Morlais Project

Terrestrial Ecology Assessment Update

Document Reference: MMC189 MOR-RHDHV-DOC-0110

Updated assessments for terrestrial ecology (excluding chough) in response to comments made on the Environmental Statement by NRW and RSPB – version 03

Figure: 1

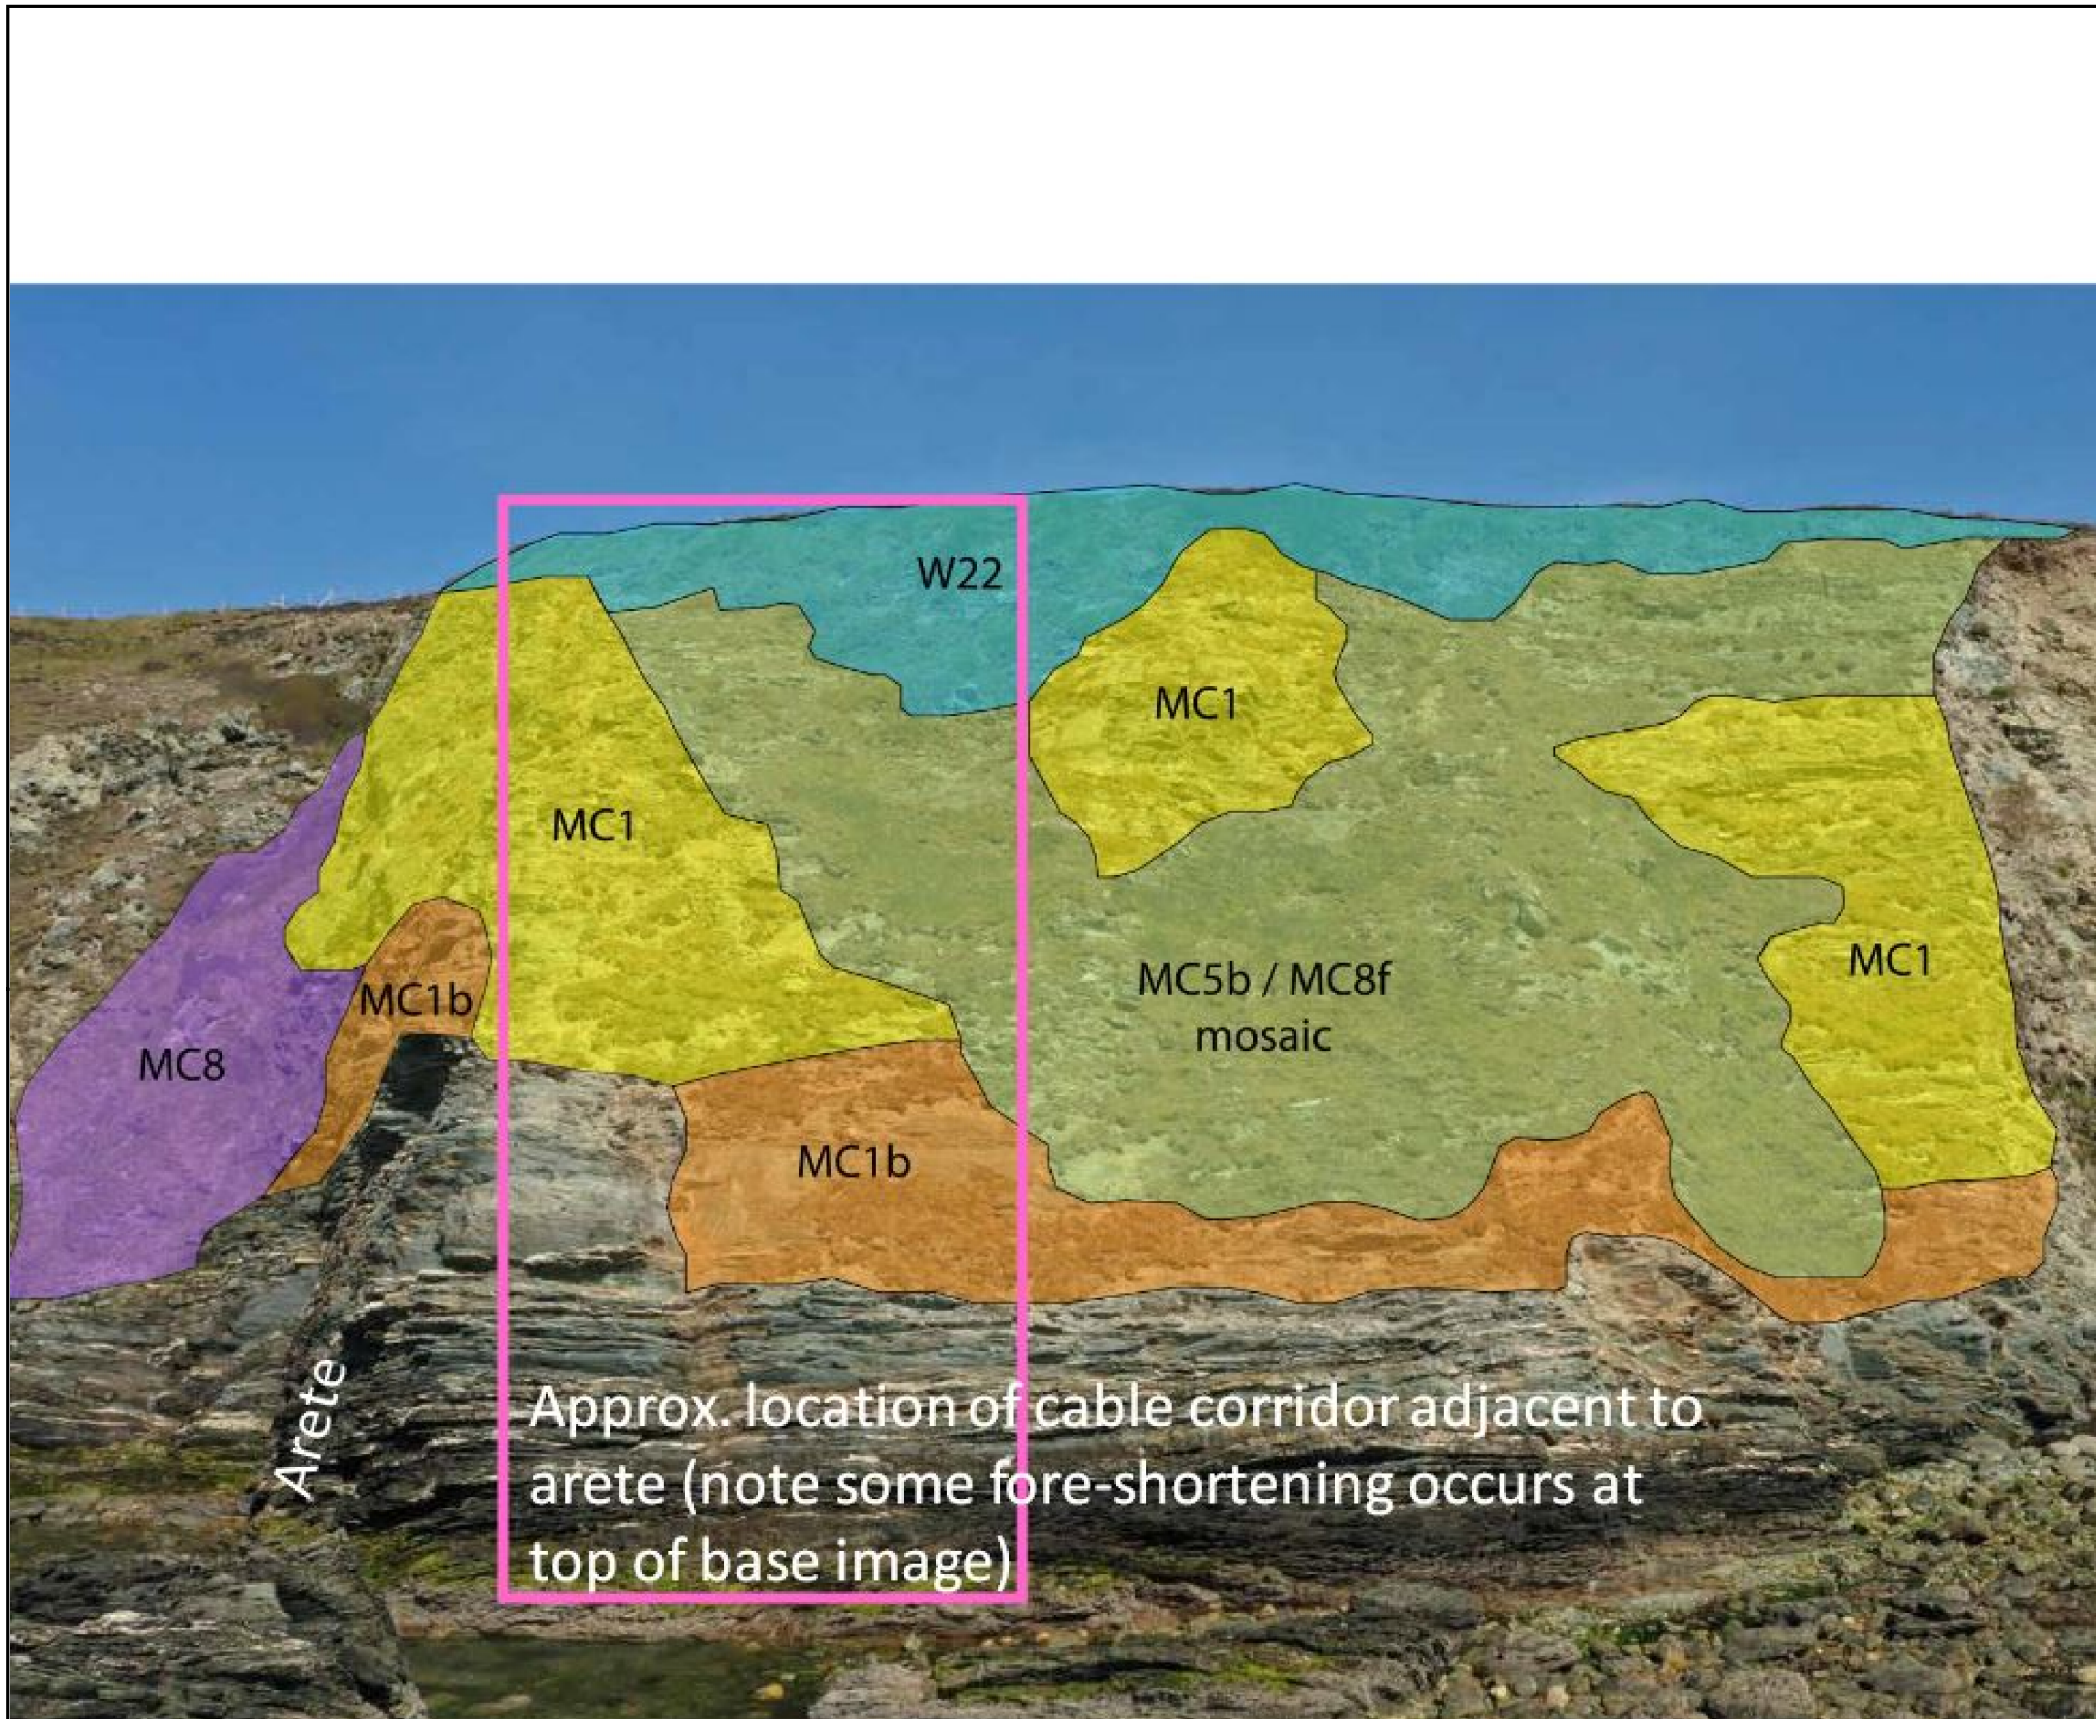
19	We would seek clarity over the reasons why Option A has been selected over Options B and C, as from Figure 1 it appears that a larger area of vegetated vertical sea cliff would be affected compared to Option C and to a lesser extent Option B. We would value seeing the process and reasons as to why Options B and C have been ruled out.	The project engineers (Black & Veatch) determined that Option A has the greatest stability for allowing the engineering of pinning the cables to cliff.

Comment Number	Comment Detail	Morlais Response
		Options B and C were discounted prior to application due to significant areas of fractured rockface (B) and access restrictions for construction machinery / proximity to only public right of way to beach (C). Both Options B and C would also require impacting a larger section of cliff and vegetation than Option A. A is the most stable area for pinning the cables to.
20	It is difficult to anticipate what the effects of the J- tubes 400mm from the cliff will be. During installation we would expect almost all vegetation within the working zone to be damaged, but roots may persist and may regrow. We will have a better idea about how fragile the vegetation is after the survey.	Assessment assumes worst case of all being removed for the life of the project (>40yrs), although the methodology proposed has been designed to minimise loss of vegetation if at all possible. (See Sections 5 and 6).

Figure: 2

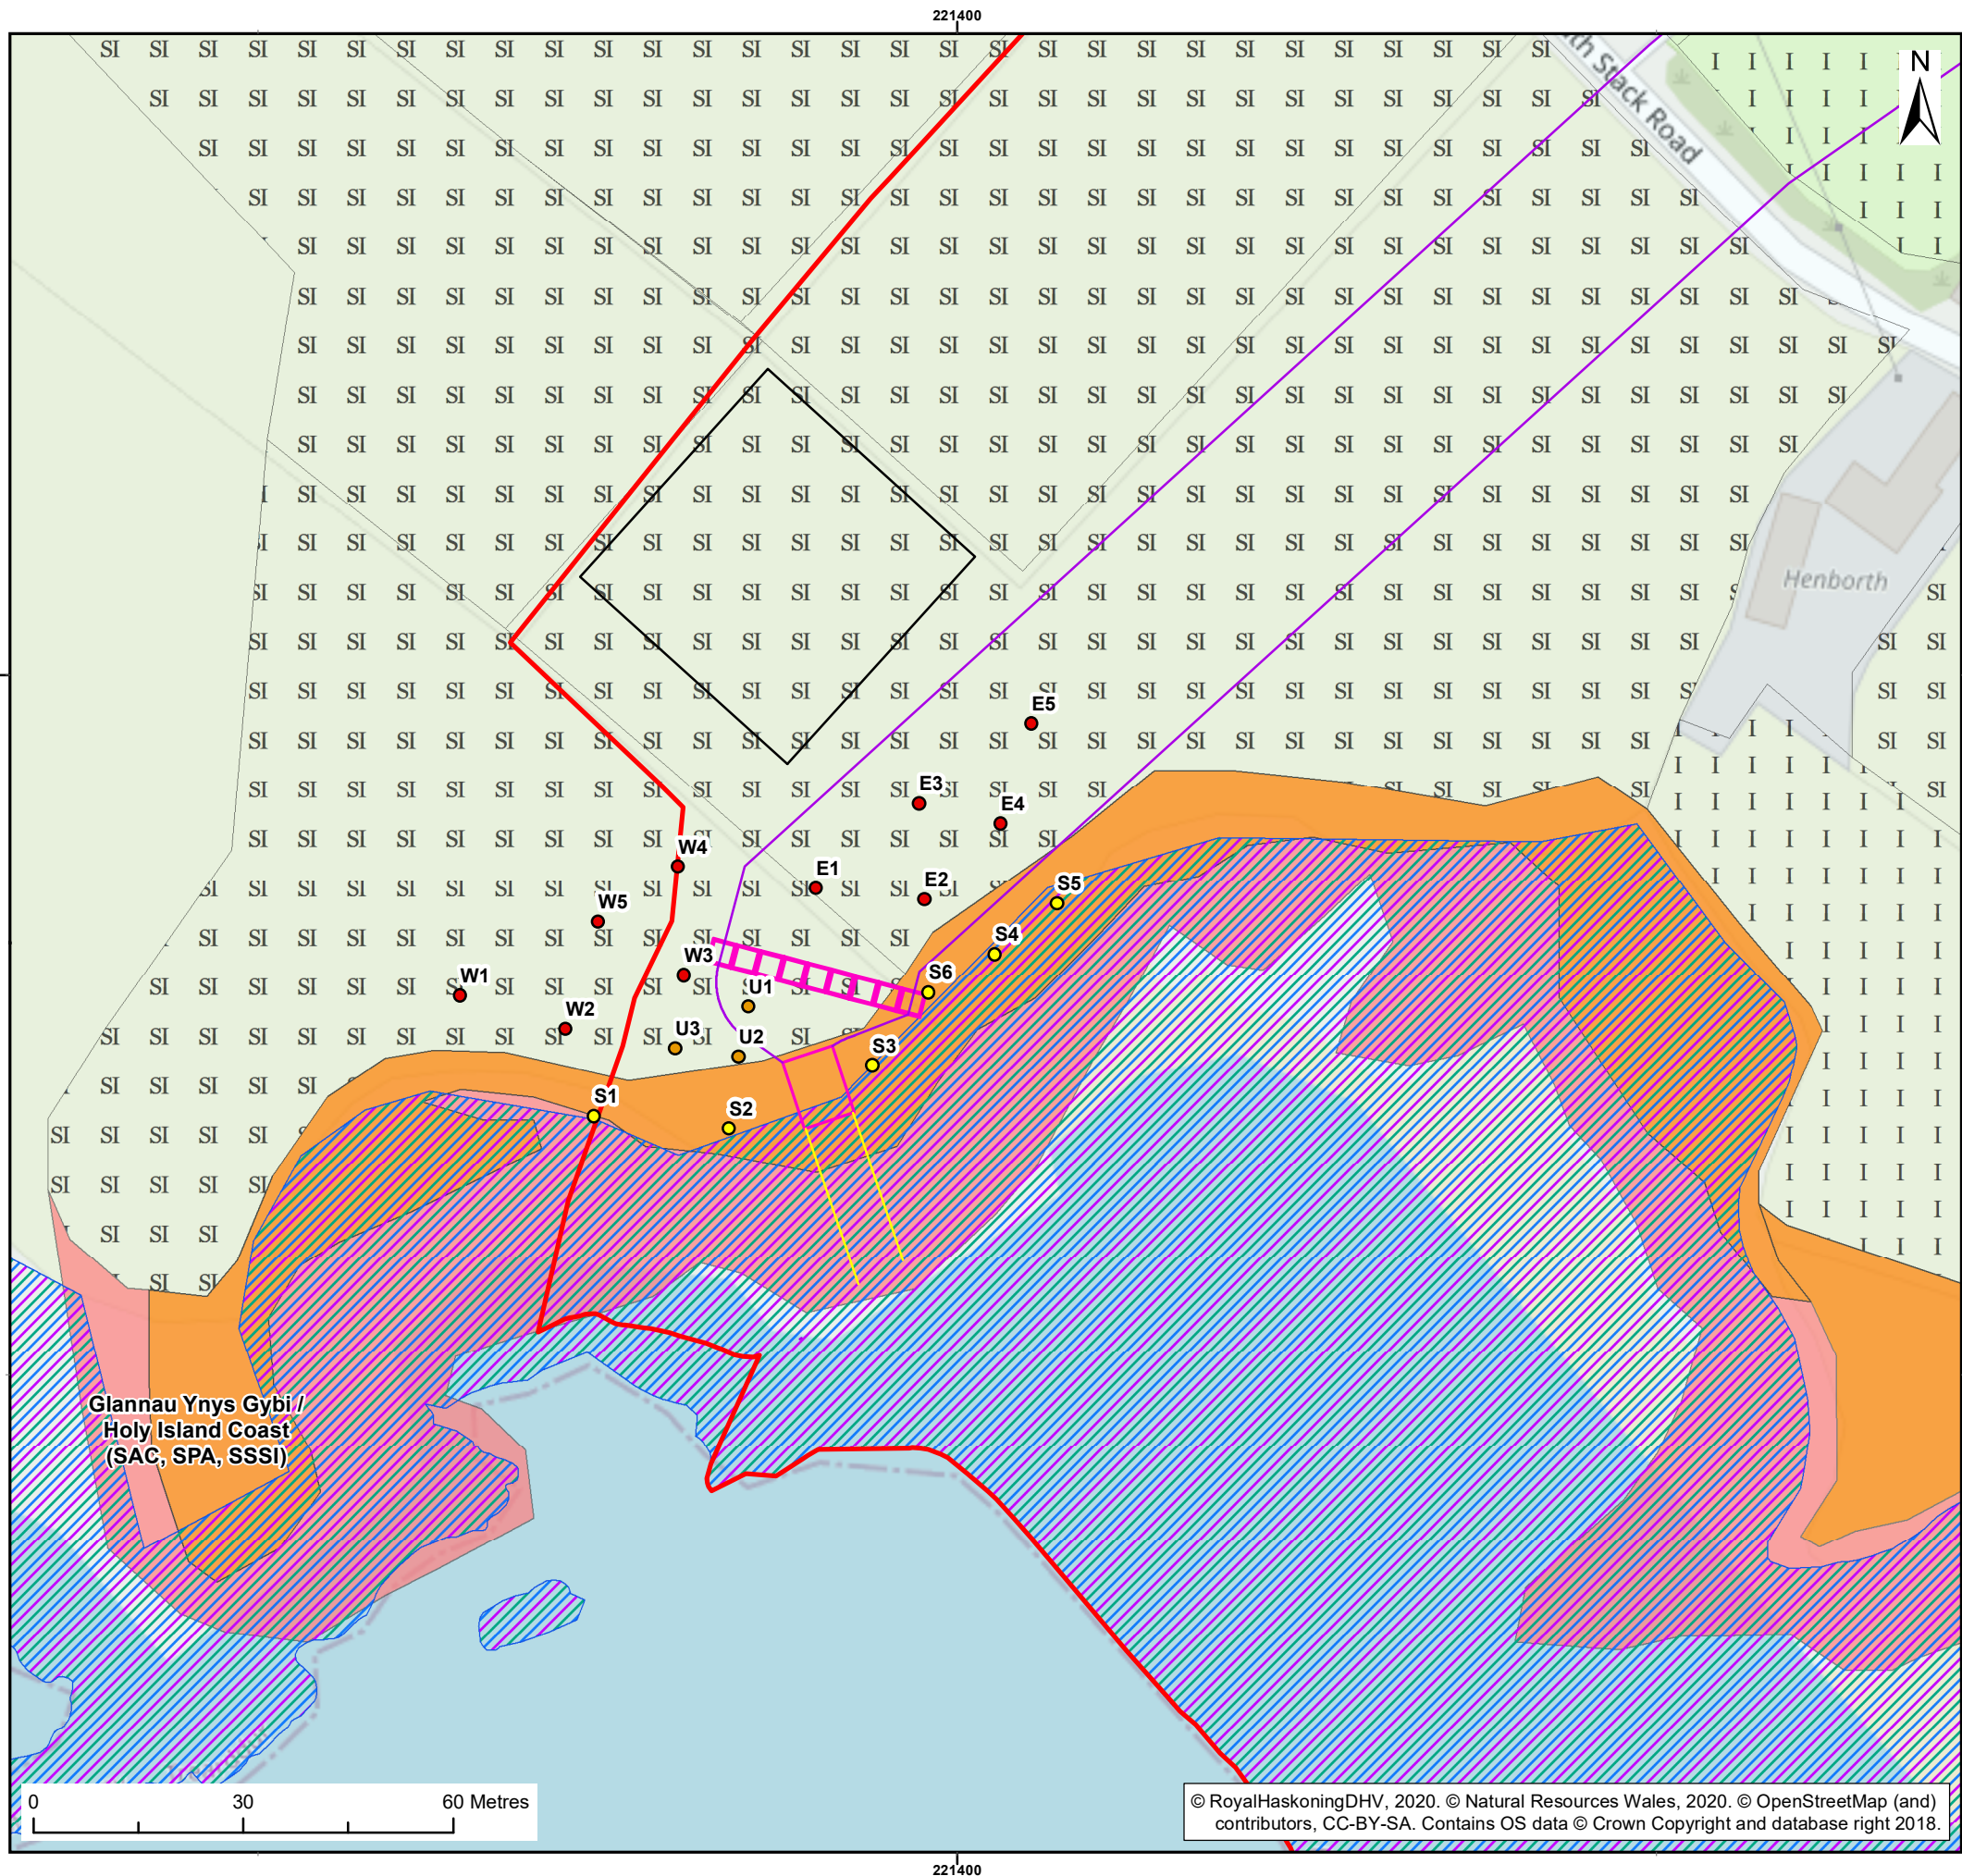
11	<p>A.60 Section 9 of the Terrestrial Ecology Assessment Update and the Information to Support an HRA, regarding conservation objectives for the SAC, has not referred to the SAC management plan so should be updated with reference to this document.</p>	<p>The SAC Management Plan is discussed in Section 9.</p>
12	<p>A.61 Two of the proposed draw pits appear to be within the vegetated sea cliffs Annex 1 habitat. Although not part of the Holy Island Coast SAC it is a valuable supporting habitat without which the designated habitats would be poorer. If the pre-construction vegetation survey confirms this, we suggest that efforts should be made to relocate the pits in less valuable habitat.</p>	<p>As is shown in Figure 2, the draw pits situated above the cliff are located outside of the Annex I vegetated sea cliff habitat, located within the unmanaged MG1e / MG5 / MC9b grassland and W22 scrub habitat, which</p>

Comment Number	Comment Detail	Morlais Response
		were identified within the Botanical Survey of Cliff Vegetation as not forming part of the Annex I vegetated sea cliff habitat. In addition, there is flexibility to microsite the draw pits during detailed design to ensure that they are located outside of the Annex I habitats during construction.
14	A.63 J-tube bolts should be sufficiently durable to last for at least 4 years in this exposed location. If not, the need for bolt replacement could lead to significant increased disturbance to the cliff vegetation.	It is anticipated that the J-tubes and rock bolts will be robustly designed accounting for the exposed environment. It is therefore not expected for replacement or maintenance works to be required for well in excess of 4 years following installation (i.e. design life is well in excess of 4 years). Maintenance is discussed in Section 5.2.2.
